**FIRST ADDENDUM TO THE
SUPPLEMENTAL ENVIRONMENTAL IMPACT REPORT
FOR THE OAKLAND ARMY BASE AUTO MALL
PROJECT**

**ADDRESSING PROJECT CHANGES RELATED TO SITE LAYOUT AND
ADDITIONAL INFORMATION ON TRAFFIC AND WASTEWATER**

**PREPARED FOR:
CITY OF OAKLAND**

December 2007

Figure 7: Wake Avenue and 34th Street Easement

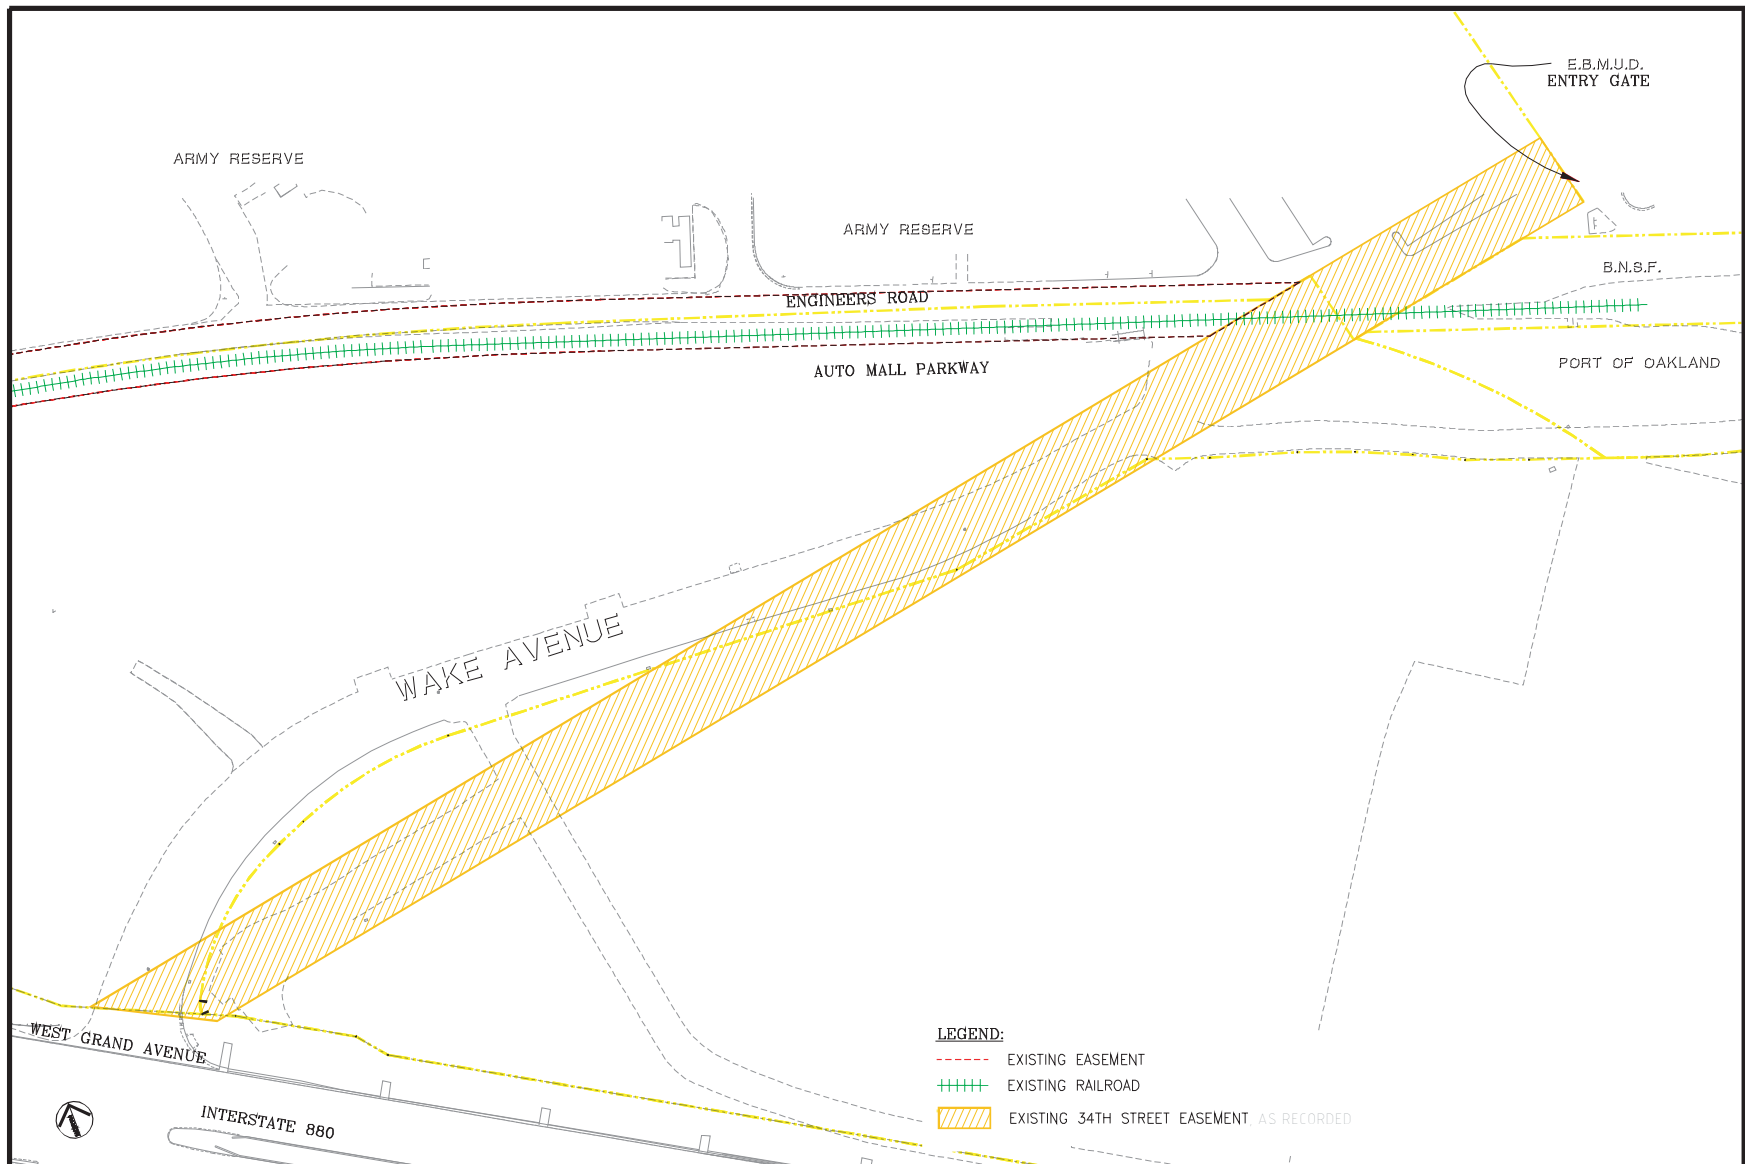
Additionally, the current ownership status of Wake Avenue has been clarified. Wake Avenue had been discussed in the Final SEIR as a private road, yet portions of this private road (particularly where it crosses the railroad tracks) overlap with public right-of-way. A portion of Wake Avenue aligns with the 34th Street public right-of-way at the railroad crossing just south of EBMUD main entrance, as shown in **Figure 7**. However, the entirety of Wake Avenue is a more circuitous route that does not wholly align with the public right-of-way nor does it meet city standards for public streets. Clarification of the issue of ownership does not change any impacts identified under the OARB Auto Mall SEIR, or the mitigation which specifies that the final design of the roadway and intersection with EBMUD access must provide adequate levels of safety, meet city standards, and that reasonable access to the EBMUD facilities must be maintained at all times. A separate process for street vacation of all or part of the 34th Street Easement (and thereby Wake Avenue) will need to be undertaken by the City, pursuant to the Streets and Highways Code.

Figure 13: Engineer Road Alternative

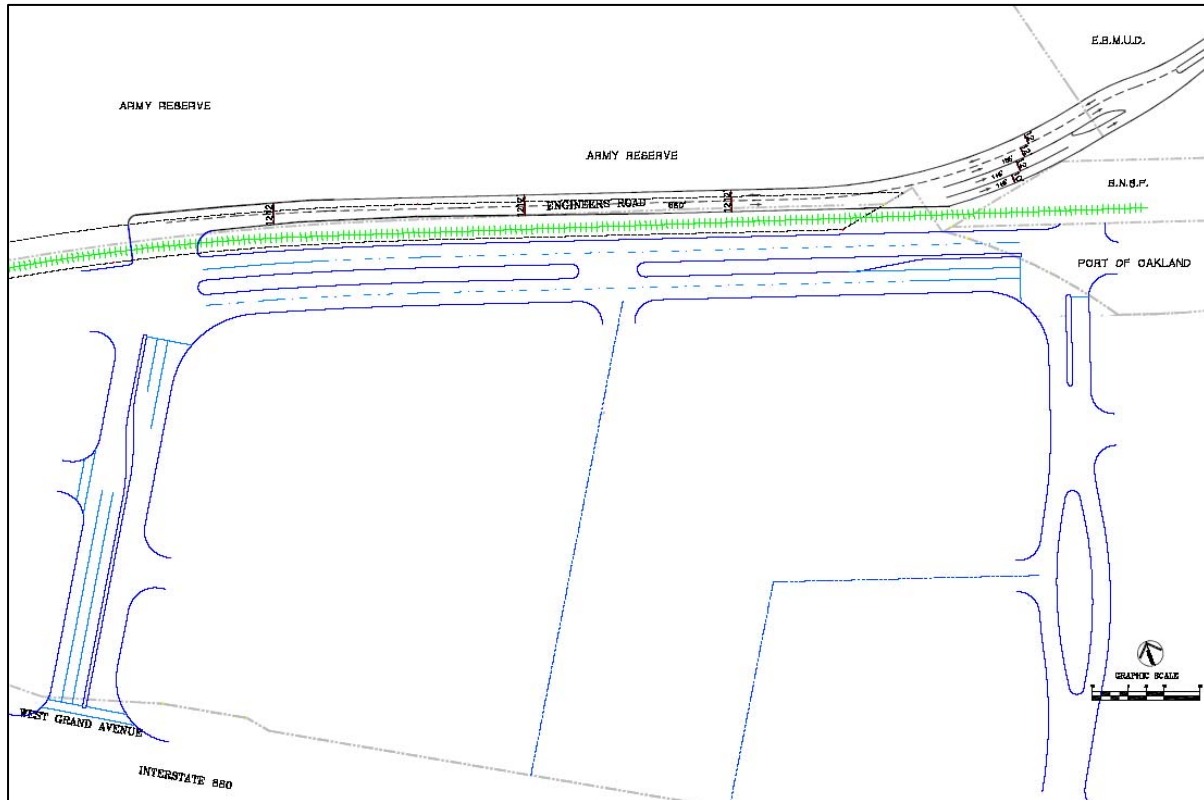
The Engineer Road access option (Figure 13) would use the parallel road along the north side of the BNSF spur track known as Engineer Road with a rail crossing around a sharp 90-degree bend at the intersection of Maritime Street and the North Access Road. The Wake Avenue rail crossing would be abandoned and EBMUD access would be via Engineer Road. It is anticipated that all Army Reserve driveways would retain access to Engineer Road. The Engineer Road access option would remove the rail crossing from the influence of

locomotive turnarounds at the wye, as this new crossing would be located to the west of anticipated locomotive turnaround movements. Train operations along the BNSF spur would still affect traffic operations at the crossing.

Queuing for the Engineer Road access option would be provided on Maritime Street between the railroad tracks and West Grand Avenue. Similar to the other access options, a train arrival during the peak period would block the entry to Engineer Road for 2 minutes, the average queue would be about 90 feet, and the 95th percentile design queue would be approximately 200 feet. Train blockages for this access option would cause one of the northbound Maritime Street lanes to be blocked, leaving one lane to accommodate Auto Mall traffic. The distance from the rail crossing to the intersection of Maritime Street and West Grand Avenue is approximately 450 feet, leaving adequate queuing capacity without impacting that intersection.
